TECHNICAL EVALUATION REPORT
TECHNICAL BASIS FOR REDUCTION OF TORUS SHELL
CONDENSATION OSCILLATION LOADS FOR THE
NIAGARA MOHAWK POWER CORPORATION
NINE MILE POINT UNIT 1

*January 1994
Revised May 1994*

*Office of Nuclear Reactor Regulation
Nuclear Regulatory Commission
Washington, D.C. 20555*

Figure 1-BNL Method of Images Predicted Variation of Pressure in the Computation Cell Plane of Symmetry- $\bar{P}(X,0,Z_0/2)$

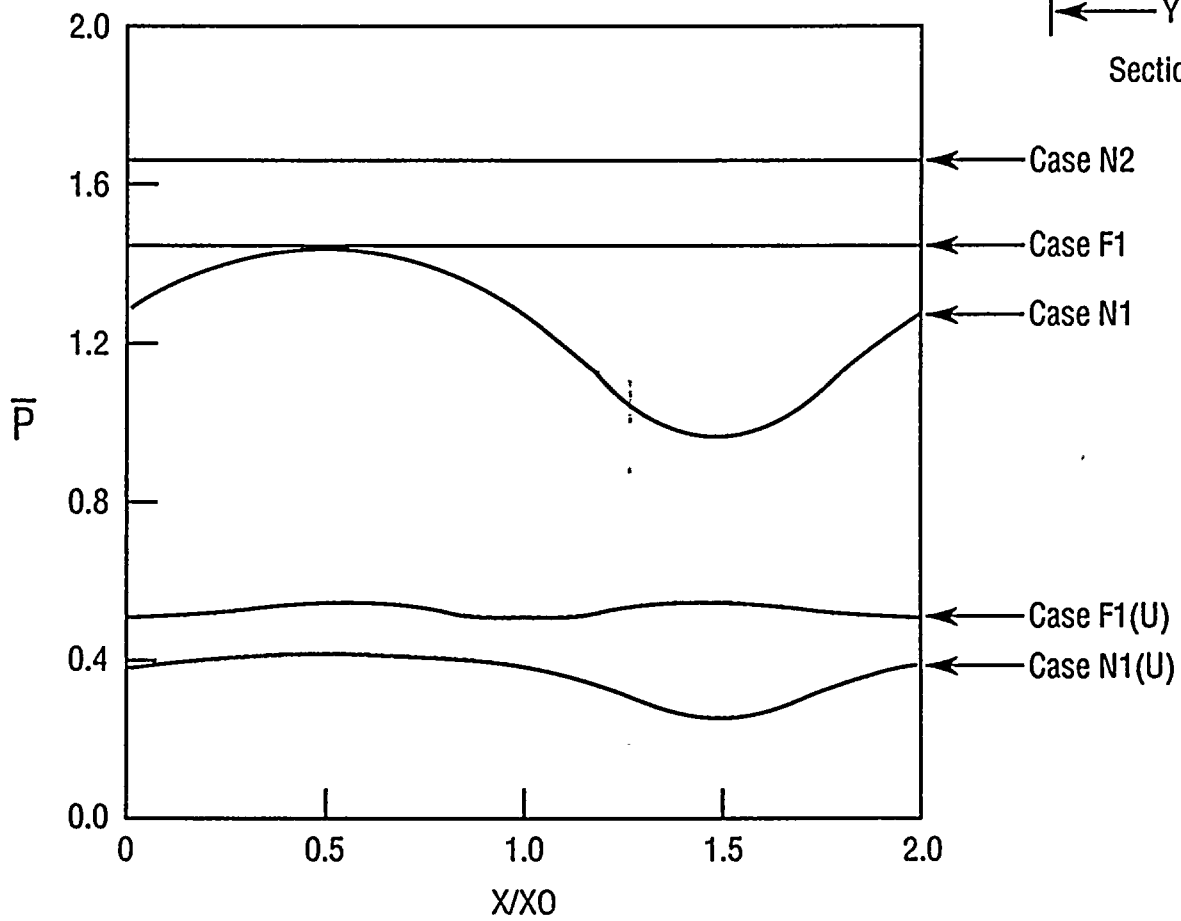
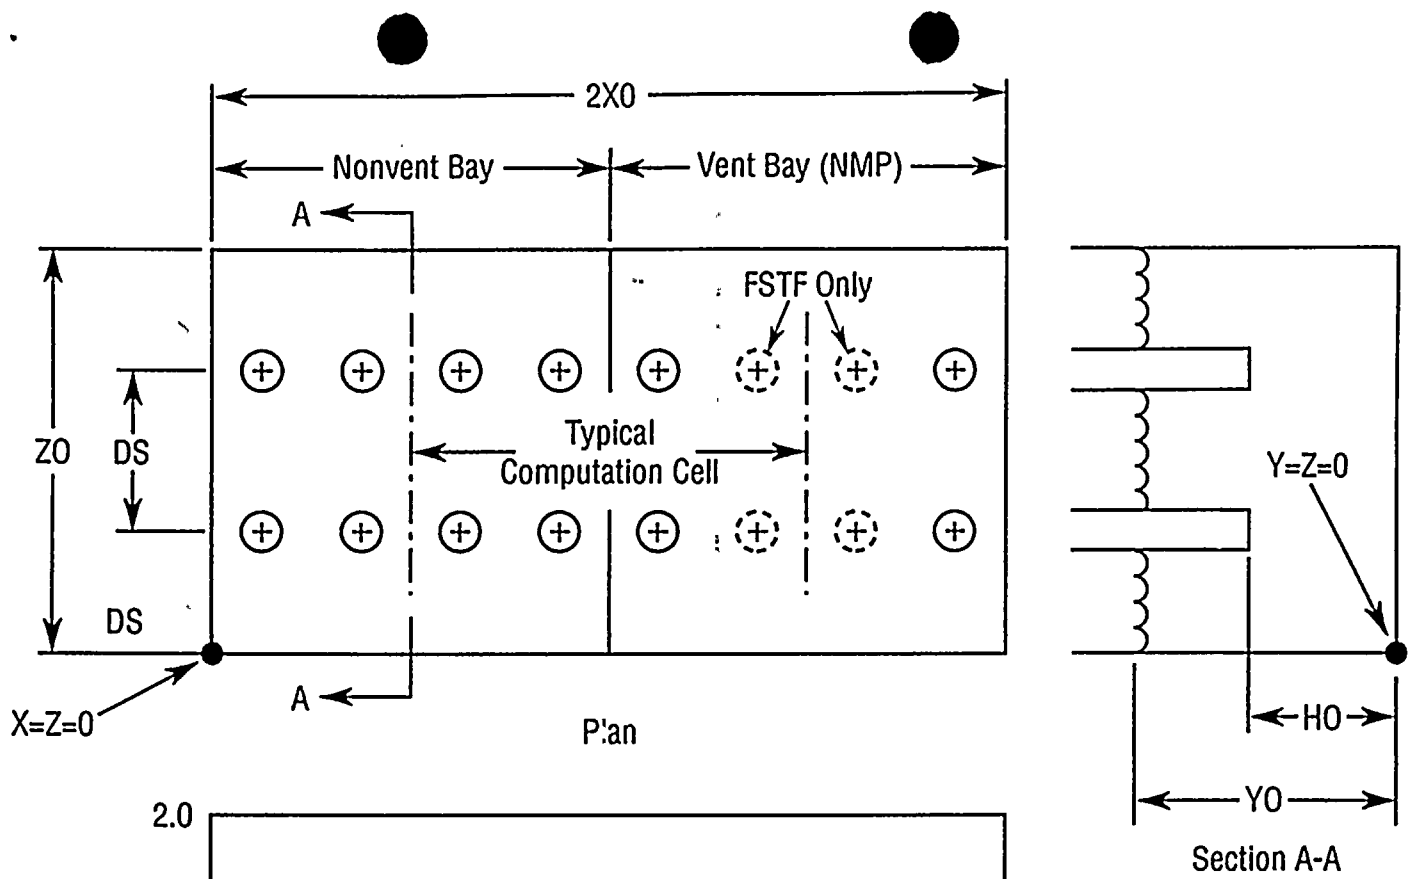
Referring now to Figure 1, the most significant of the results shown there is the large reduction in pressure that is obtained when the sources are no longer correlated. Even for the FSTF, the pressures are reduced to only about one third of the correlated values. Interestingly enough, this is more or less the order of magnitude of reduction in pressure amplitude between the fundamental frequency (about 3 psi for 5 Hz) and the other non-synchronous values (1 psi maximum) as indicated in Table 4.4.1-2 of Reference 1.

Figure 2- Comparison of BNL and NMPC Estimates for Pressure Amplitude Reduction Factors

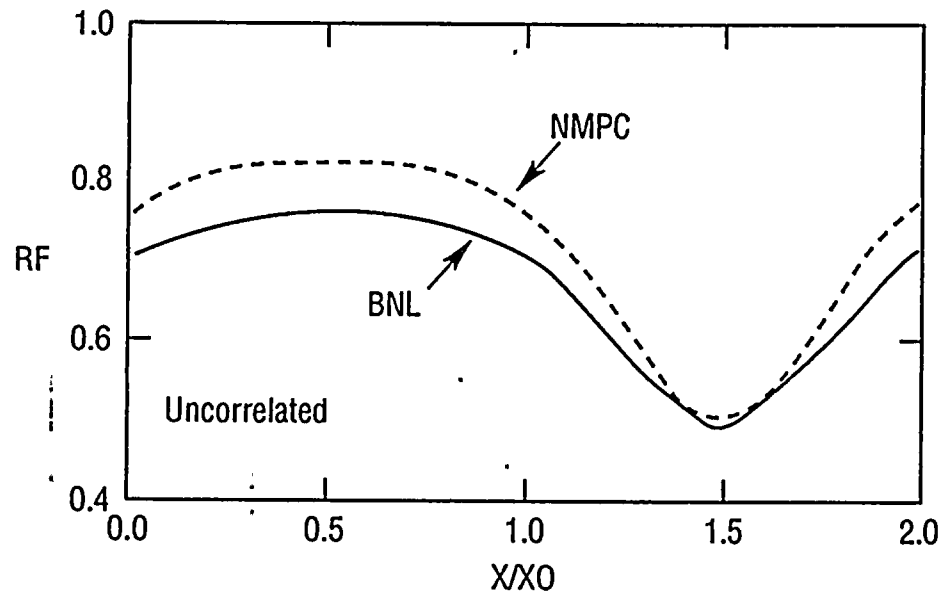
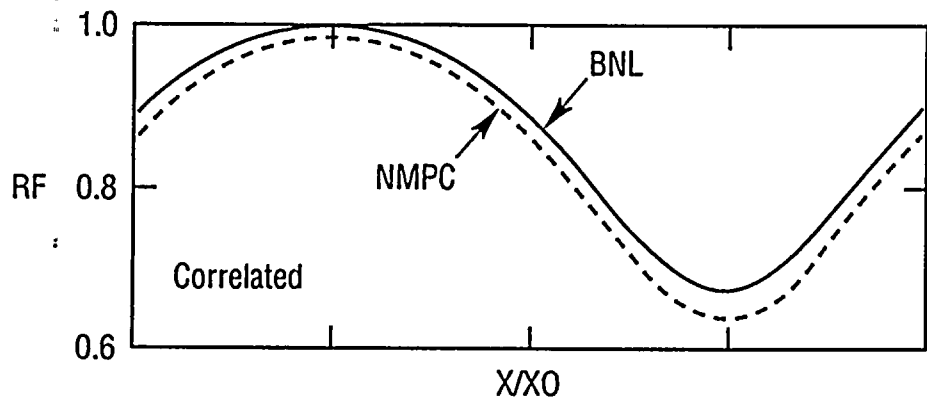
Comparison of the BNL and NMPC values of the RFs shown in Figure 2 indicate clearly that they are in very good agreement. Note especially that the NMPC's uncorrelated RFs are more conservative than BNL's. That is, the LDR pressure amplitudes are reduced less when the NMPC RF's are used. Some nonconservatism is exhibited for correlated RF's but this difference is, at most, 6%. These differences are considered minor and, in our judgement, do not invalidate the acceptability of the proposed modifications.

Figure 3- Results of Sensitivity Studies for NMP via the BNL Method of Images

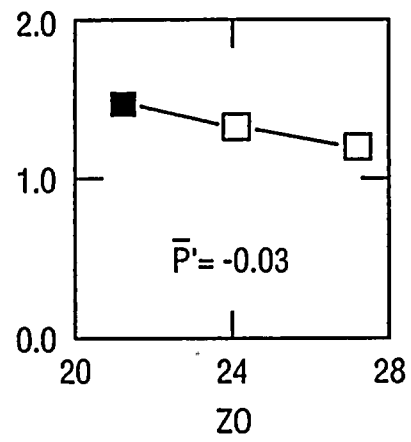
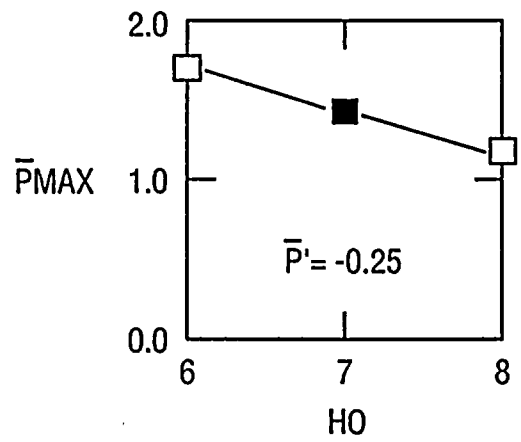
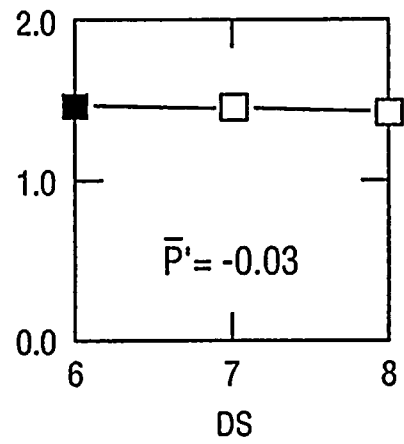
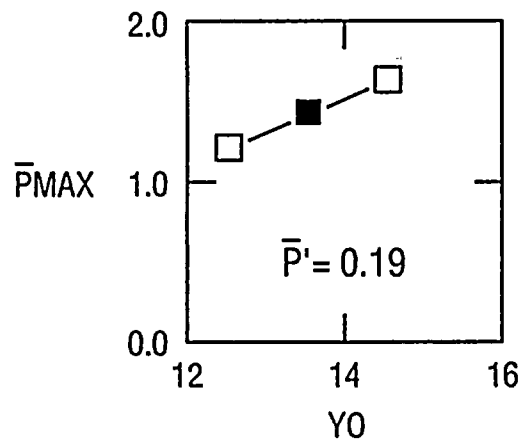
With respect to the sensitivity studies that were performed, we note first that they were motivated by the result obtained for Case N2 of Table 2 corresponding to a computational cell with the NMP geometry but with four rather than three pairs of downcomers. Although

As can be seen by referring to Table 2, the value of PMAX corresponding to Case N2 (1.66) not only exceeds that for Case N1 (1.45), which is to be expected, but also exceeds the value predicted for the basic FSTF case (Case F1). This increase can only be attributed to geometric differences since source number and strength are identical for those two cases. The same sort of difference is exhibited between the Case F2 (PMAX = 1.24) and the Case N1 (PMAX = 1.45) results. Note that these latter two cases correspond to 8-4-8-4 type configurations. These findings were the motivation for the sensitivity studies that were conducted; ie: to determine what feature of the NMP torus geometry gives rise to pressure loads higher than those expected in the FSTF for the same number of downcomers. As can be seen from the results shown in Figure 3, the noted increases are primarily the result of the significantly smaller clearance (7 vs 7.8 ft) that prevails in the NMP torus. One implication of this finding is that the FSTF geometry was not strictly applicable for NMP both with respect to the latter's 8-4-8 downcomer arrangement (a conservatism), but also with regard to downcomer clearance (a non-conservatism). The trade-off between these two opposing effects suggests that the original NMP design loads were suitable, notwithstanding that, to the authors' knowledge, no adjustment for the effect of reduced clearance was made or considered.

A more positive interpretation of this finding would be that CO loads could be reduced by an increase in clearance at NMP; ie: by shortening the length of the downcomers. According to Table 2 (Case N8 vs Case N1), a decrease in PMAX of almost 20% could be achieved by removing 12 inches from the downcomer ends. Of course, such a modification would involve significant expense but might be a cost-effective alternative to the structural modifications currently under consideration by NMPC in the event they become necessary. Note that a reduction of HO implies a corresponding reduction in downcomer submergence which tends to mitigate pool swell loads (Section 3 of Reference 3). However, it also potentially reduces the steam condensing performance of the suppression pool. Thus a total system analysis would be required to determine the merit of this concept.
